Hume Coal Project EIS

Independent Expert Review

Groundwater Modelling

16 October
2018

Figure 1 - Interburden thickness (after Coffey 2016a, Figure 4.3)

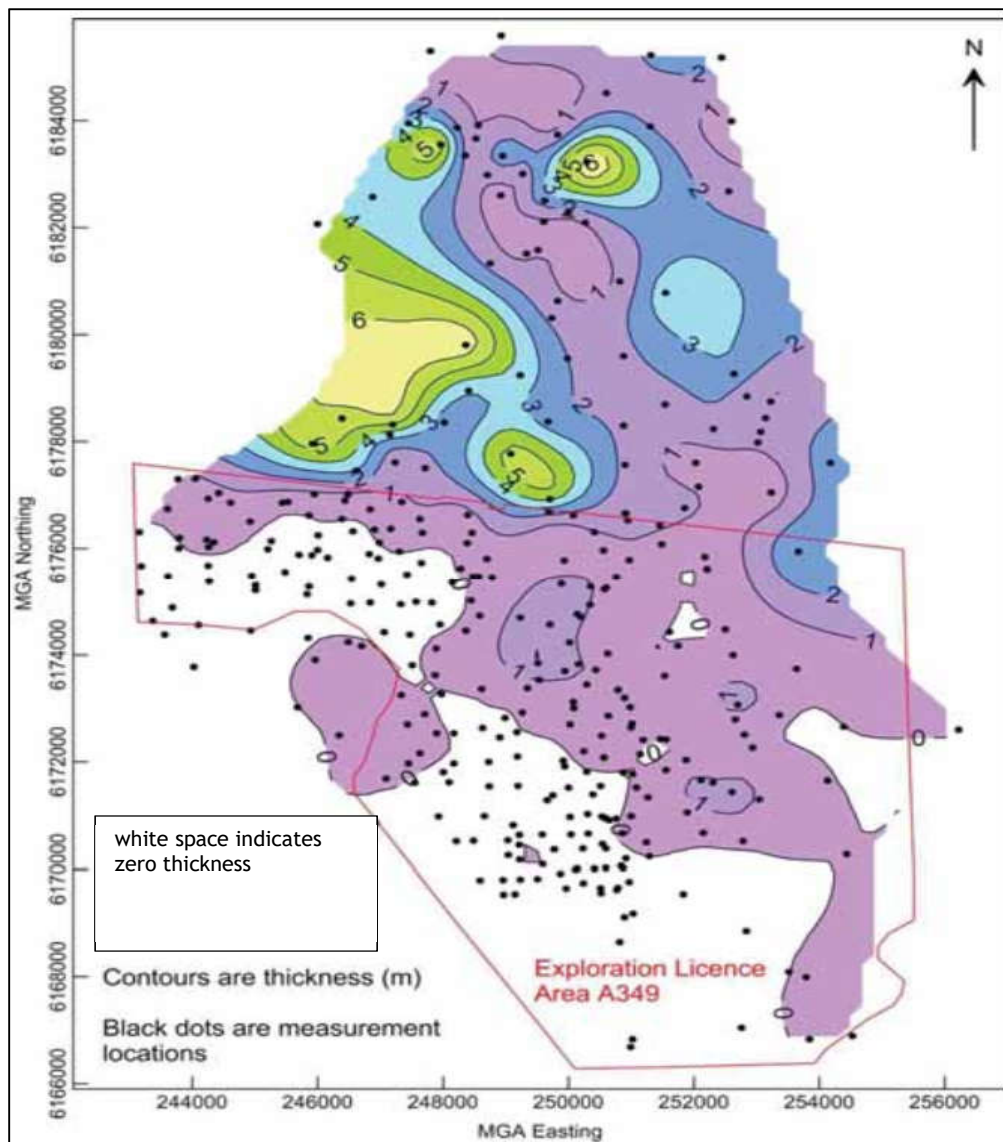
Dr Merrick indicated during review discussions (see Issues Log item 3 in Appendix A) that his internal review of the model identified issues with the implementation of the interburden (layer 8, comprising the combined Narrabeen Group, Wongawilli Ply and Farmborough Claystone) that warranted corrective action in terms of extending the relaxation zone up into layers 6 and 7 in some areas of interburden absence (Figure 1).

- a minimum thickness of 0.4m is applied to layer 8 (interburden) in areas where the interburden is absent (Figure 1), but in those areas, the parameters applied are the same as those for the Wongawilli mined seam;
- a minimum thickness of 0.29m is applied to the underlying layers 9 and 10 (the Permian units between the interburden and the mined seam);
- thus, a combined minimum thickness of 0.98m applies to layers 8 to 10, between the roof of the mined coal seam (top of layer 11) and the base of the Hawkesbury Sandstone, and all these layers have the same parameters as the mined seam.

The EIS report (Coffey, 2016b) had confusingly and erroneously described the thickness of the layer 8 interburden in various ways: average layer thickness of 4m and minimum thickness of 0.1m. Similarly, layers 9 and 10 are described as having an average thickness of 2m and a minimum thickness of 0.1m. This has been clarified satisfactorily in the revised modelling report.

In other areas, the known interburden thickness (Figure 1) is applied to layer 8 of the EIS model, and similarly for the layers 9 and 10 thickness. However, the aquifer parameters applied to layers 6 to 11 are representative of the coal measures (Figure 2; see later). This means that low permeability parameters are not applied to the interburden layer in the EIS model, as illustrated in Figure 2 in terms of the model values for the interburden being higher than most of the test results for the deep units.

The areas of zero interburden thickness (Figure 1) align with areas where the mined coal seam thickness (layer 11) is less than 2.6m. Appendix A of Coffey (2016b) presents a figure showing

The revised modelling (HydroSimulations 2018) confirmed that the interburden thickness and hydraulic conductivity properties are satisfactory, but that, in some areas, the drain cells (representing mine drainage) extended from layer 11 (the mined seam) only up to layer 10 in the EIS model. The revised modelling applied corrective action to extend the drain cells through the 2m height of the relaxation zone (i.e. to layer 7 in some areas). The revised modelling has also justified the application of satisfactory property values, while invoking a depth-dependent hydraulic conductivity relationship based on testing data from the Hume area and the Southern Coalfield. The results indicated relatively low sensitivity/uncertainty in terms of inflow volumes.

In summary, this review has found that the Hume Coal model (EIS and revised model versions) has been set up with an appropriate representation of the interburden properties (e.g. appropriate thicknesses and no low permeability parameters to limit the potential connection between the coal seams and the Hawkesbury Sandstone). The relaxation zone treatments applied to the EIS model received corrective action during the revised modelling, and the results indicate fairly low sensitivity/uncertainty in terms of key performance indicators (inflow volumes, drawdowns, bores affected and stream baseflow).

Figure 2 - observed and modelled hydraulic conductivity (after Coffey, 2016b, figure 4.5 and Pells, 2017, figure 2.12)

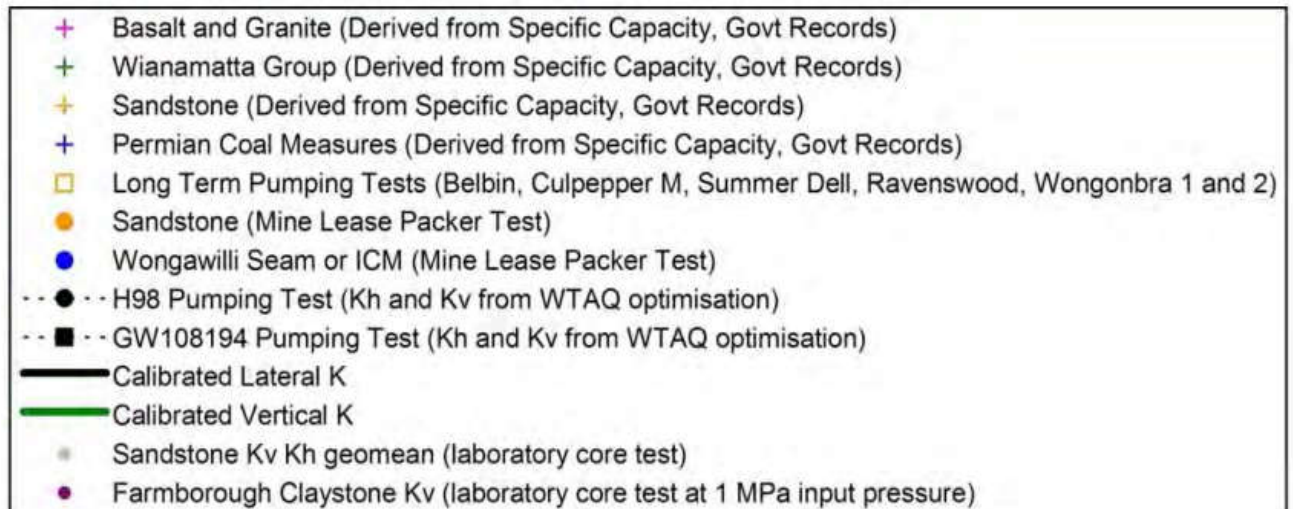
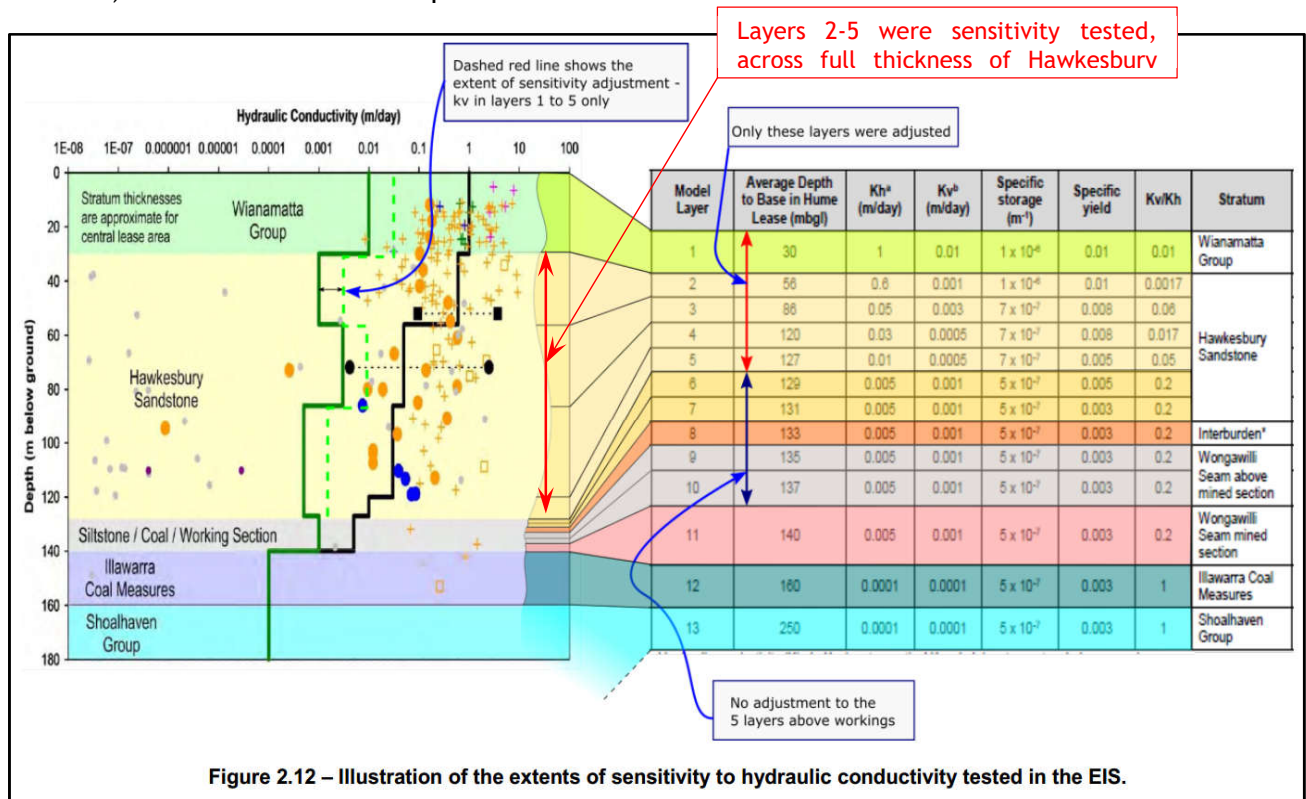
The Hawkesbury Sandstone Kh values applied to the EIS model are reasonable in that they lie in the middle of the range of observed values (Figure 2); clearly not at the high end of the range as suggested by Pells (2017), but also not at the low end of values (mainly from core testing, indicated by grey dots in Figure 2; see also Figure 3). Most of the pumping tests on individual bores (open square symbols in Figure 2) do indicate higher range Kh values, but that is for tests mostly in the higher elevations of the Hawkesbury Sandstone, including the two tests on bores on the Hume lease (H98 and GW108194 indicated by the solid black symbols). Again, the model reflects this effect of higher Kh in shallower units. The exception is the high Kh for the (unnamed) bore at about 110m depth.

The EIS model has been tested for sensitivity to Hawkesbury Sandstone vertical hydraulic conductivity (K_v) across the full thickness of the Hawkesbury Sandstone (Figure 2), concluding that the mine inflow predictions are sensitive to K_v , as is often the case in practice.

While sensitivity to horizontal hydraulic conductivity was not tested for the EIS model (Coffey, 2016b), a rigorous uncertainty analysis on lateral and vertical hydraulic conductivity of the Hawkesbury Sandstone has been conducted during the revised modelling (HydroSimulations 2018), based on the relationship shown in Figure 3. The uncertainty analysis was conducted consistent with the principles in the latest guidance (Middlemis and Peeters 2018) and concluded the relatively low uncertainty/sensitivity effects on the predictions.

Figure 3 - variations of K_h with depth (after HydroSimulations 2018, Fig.18)

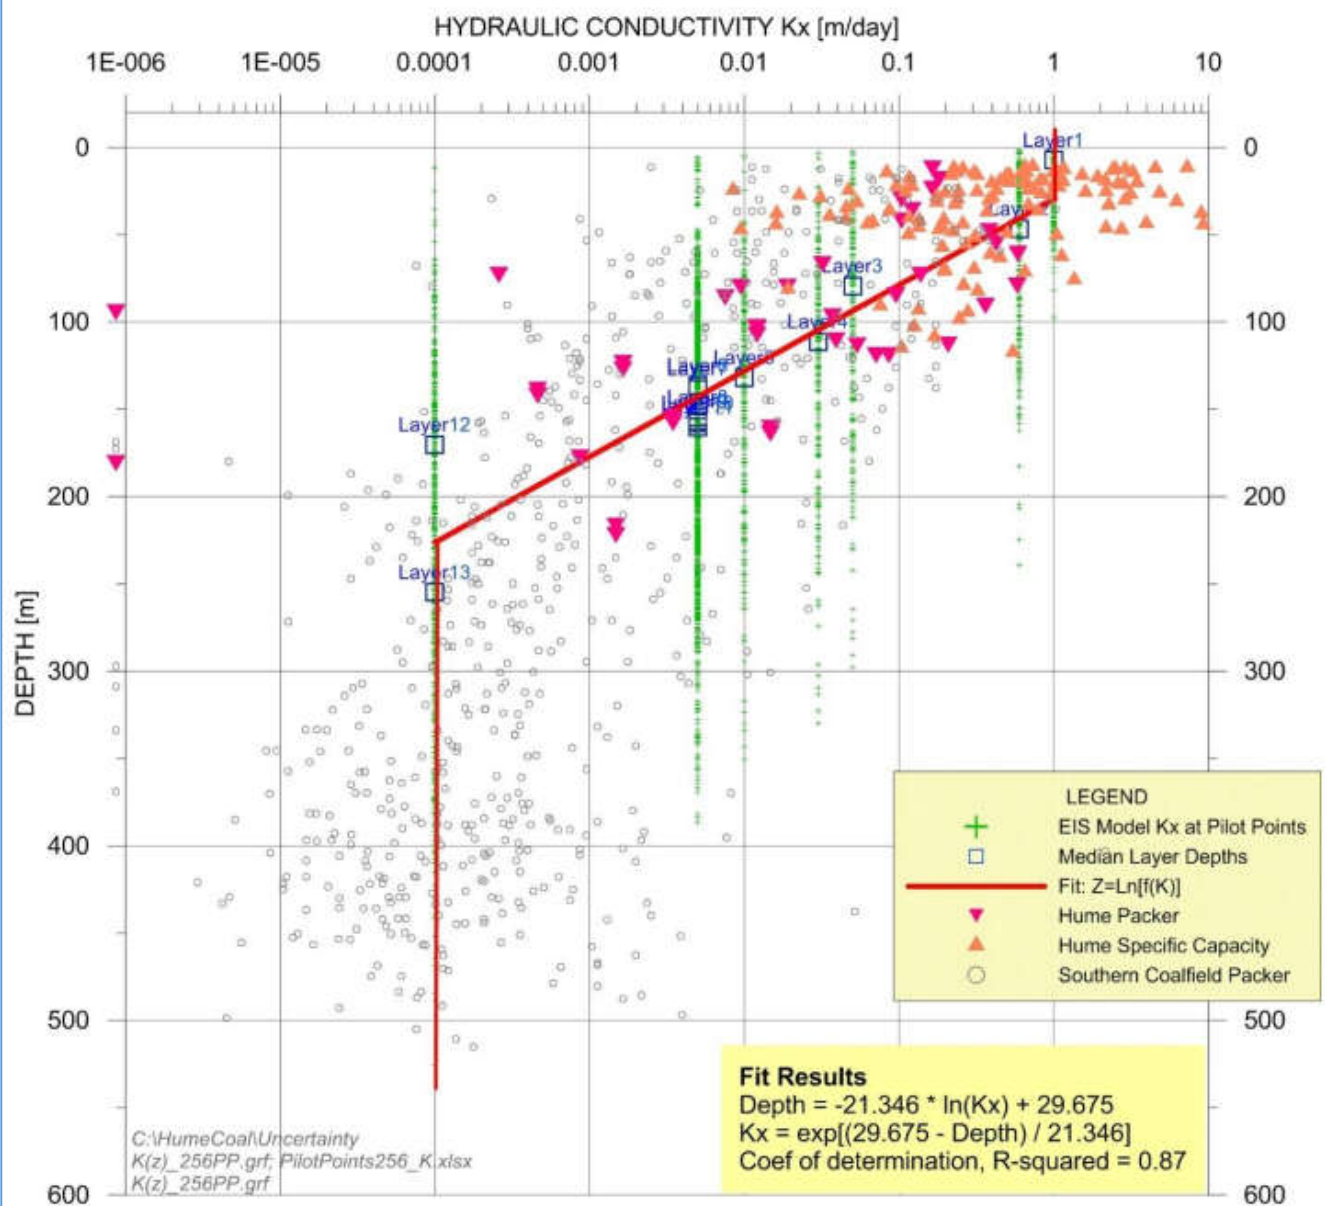
The basal unit of the Hawkesbury Sandstone is Layer 5 in the Hume Coal EIS model, nominally 7m thick and with a horizontal hydraulic conductivity (K_h) value of 0.01 m/d. This is a lower K_h than the overlying bulk thickness of Hawkesbury Sandstone layers 2 to 4 (K_h range from 0.6 to 0.03 m/d; Figure 2), consistent with the conceptualisation of decreasing permeability with depth (justified by information presented in Coffey, 2016a, Appendix C). The revised modelling (HydroSimulations 2018) conducted a detailed re-investigation of the K_h variations with depth based on the test results available at Hume and across the Southern Coalfield, justifying the parameterisation applied (Figure 3; see later) and the estimation of the uncertainties applying.

Figure 4 - mine drainage feature (after Coffey 2016b, Figure 5.4)

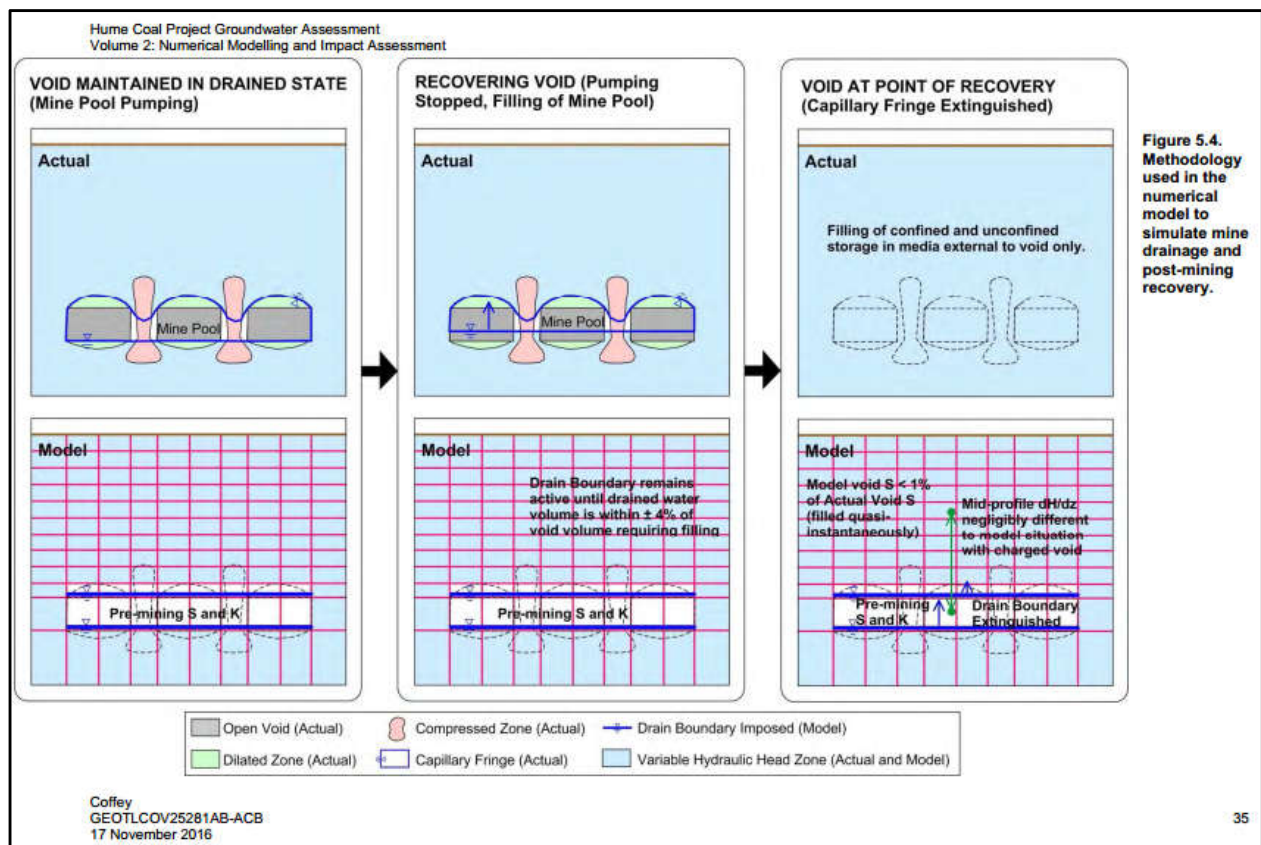
The Hume Coal model applies the “Drain” feature of Modflow to simulate groundwater inflows to the mine workings (a standard methodology); see also Figure 4 (later). The drain feature involves a conductance parameter that acts as a resistance to flow (i.e. lower values of conductance require higher groundwater gradients to result in the same amount of inflow).

The groundwater-related effects of potential bulkhead failure were not specifically considered in the EIS, but the results that have been provided can be interpreted to provide some useful information on the issue. The EIS groundwater assessment modelling method included leaving drain cells active after mining until the residual void behind the bulkhead is filled, and then deactivating the drain cells (Figure 4), although this was changed for the revised modelling.

The revised modelling method applied involves turning off model drain cells when mining is completed, such as when mining up-dip obviates the need for drain cells down-dip behind the more rapidly advancing mine face (HydroSimulations 2018). The de-activation of drain cells post-mining is a more realistic method, in that the model allows post-mining inflows to become part of the void element of aquifer storage, while the water balance analysis in the revised modelling allows for detailed reporting of the “to void” and the “to sump” volumes. See also commentary in the next section about the modelling of underground water impoundments.
